**Maryland**  
Department of  
the Environment

January 11, 2024

Subject: Dam Inspection Findings  
Emmitsburg Dam (MD Dam No. 18)

# Maryland Dam Safety Inspection Checklist

Photo 10 description: Left Filter Toe Drain Outlet

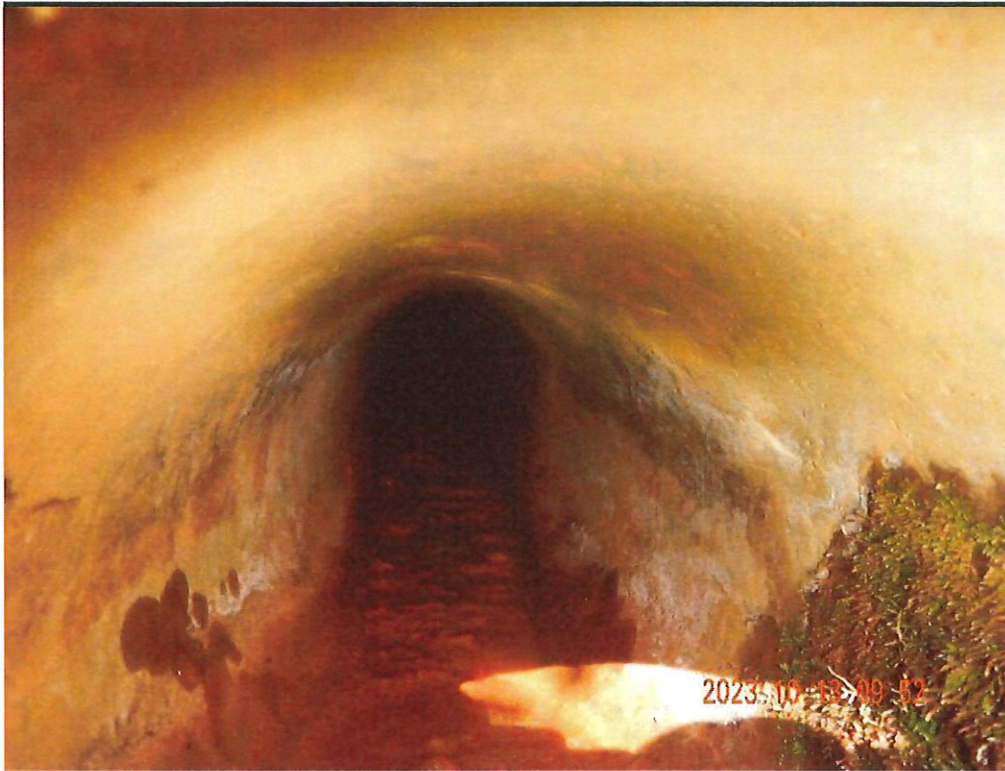
What types of embankment drains are present? Toe Drains

Approximate toe drain flow rate (gpm): < 1

Location of toe drain: Left and right of concrete spillway pad

**Describe action required:** Monitor seepage from toe drains during annual inspections.

Photo 17 description: Right Side Interior Left Riser Box

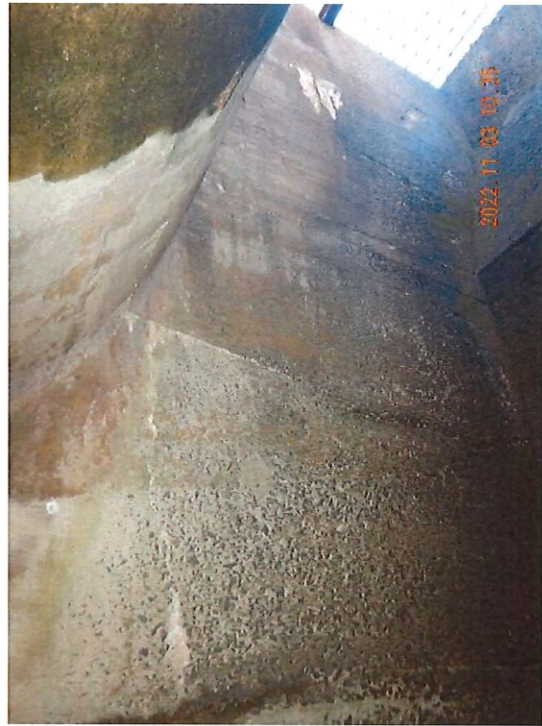
What issues are noted with the concrete components? Spalling, Surface Erosion, Scaling/Exposed Rebar, Cracks, Seepage

Spalling: Spot on the right wall of the right half of weir spillway and a few localized spots on the walls of the right and left box spillways.

Describe action required: Please retain a professional engineer experienced in dam inspections, design and construction to evaluate the concrete condition and make recommendations.

Photo 22 description: Seepage Point Left Side Interior Left Box Spillway

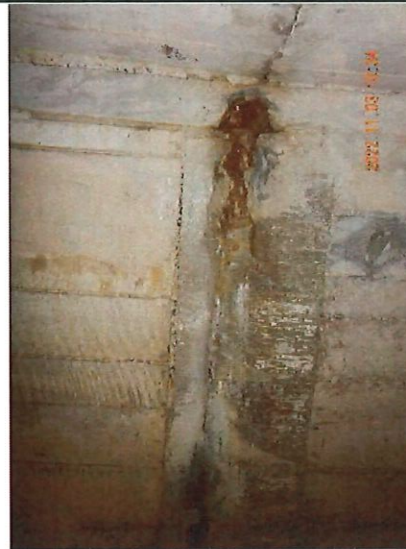
Seepage: Along the joint between the portion of the original back weir wall and the additional section of the back wall. Seepage runs down the back wall on both sides of the weir box. Another significant spot at the joint between the back wall of the left half of the spillway and the left box spillway. Multiple spots in both the right and left box spillways.

Photo 23 description: Seepage and Broken Rebar near Joint Between Back Wall Left Riser Box and Left Box Spillway

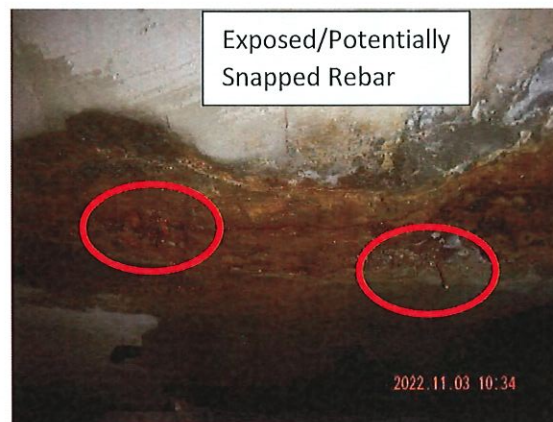
Scaling/Exposed Rebar: At the joint between the back wall of the left half of the weir spillway and the left box spillway.

Photo 37 description: Control Tower Exterior

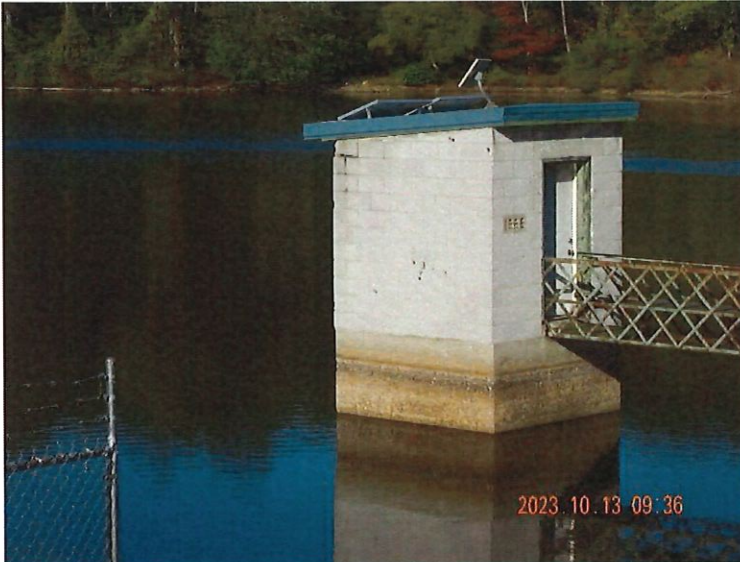
What issues are present with the lake drain? Could Not Inspect, Unknown Operability

Describe action required: Please perform any routing maintenance of the valves and exercise operable valves at a minimum annually. Please retain a professional engineer experienced in dam inspections, design and construction to evaluate the water control tower and gates/valves condition and make recommendations.
